Administrative Staff Report

Project Name: Wissmer - Critical Area Buffer Reduction (CABR)
Type of Application: CABR Type II
Permit Number: 23-00331

12935 Wye Lake Blvd. S.W.
Port Orchard, WA 98367
Commissioner District 2

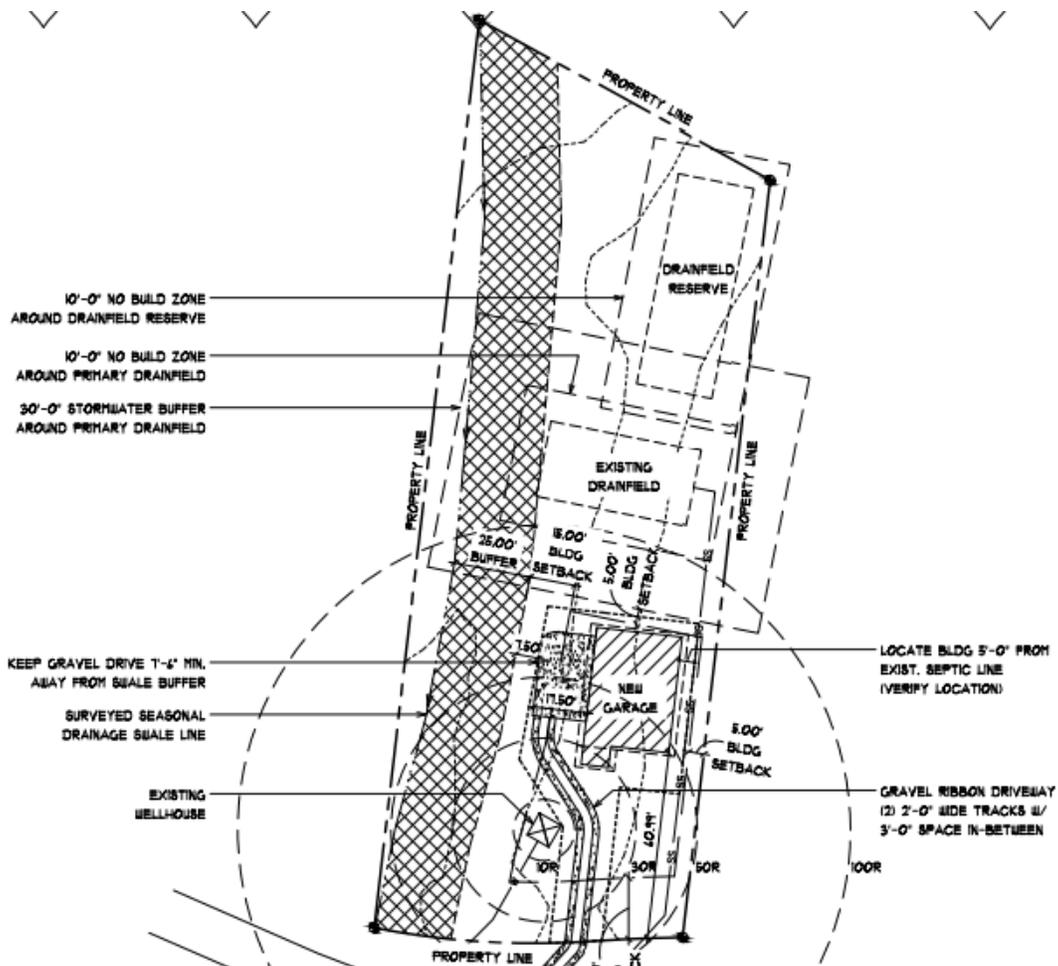
The image below shows the proposed footprint of the detached garage, the proposed driveway, associated parking, onsite septic (OSS), including drainfields and a drinking well for the benefit of the single-family residence south of Wye Lake Blvd. S.W. The site plan also shows the location of the onsite stream and those buffers.

The detached garage will require a 50% reduction to the stream buffer width and a 7.5-foot building setback totaling 32.5 feet from the edge of the buffer. A habitat management plan and mitigation report (HMP) were prepared that includes installation of 65 native plants and recommends the use of a minimum of 5 varied species installed between the stream and the new development.

Staff Comment: The site is constrained with critical areas and those buffers running along the west side of the site and the septic drain fields existing at the northern portion of the site. There is only one feasible area to build the detached garage. applicant has addressed avoidance and minimization in the proper sequencing. As the applicant comment states in the preceding section, the scope of this proposal is indicative to surrounding properties mentioned and found in exhibit titled Wissmer Report-Type II Buffer Reduction and Narrative (HMP), dated December 3, 2022, conducted by Christy Christenson, Biologist for C3 Habitat.

Staff Comment: The submitted HMP characterizes the stream buffer functions as well as areas outside of the buffer. The report states that avoidance is not possible and discusses minimization and mitigation. Plantings will be installed along the east side of the stream and west of the gravel driveway, enhancing the stream buffer. The proposed mitigation

is enhancing the resultant buffer where it is mostly dominated by Himalayan blackberry currently. The restoration area requirement is 1,815-ft² and will be exceeded by planting approximately 3,188-ft² with a diverse native plant community. The proposal minimizes impacts by placing the accessory structure in an area furthest from the stream while still maintaining the 5-foot side setback requirement as well as setbacks from the septic line at the east, drainfields to the north, and existing well at the south.

8. Vegetation planting shall occur as specified in the approved Habitat Management planting plan (conducted by C3, dated October 19, 2023), produced in support of this
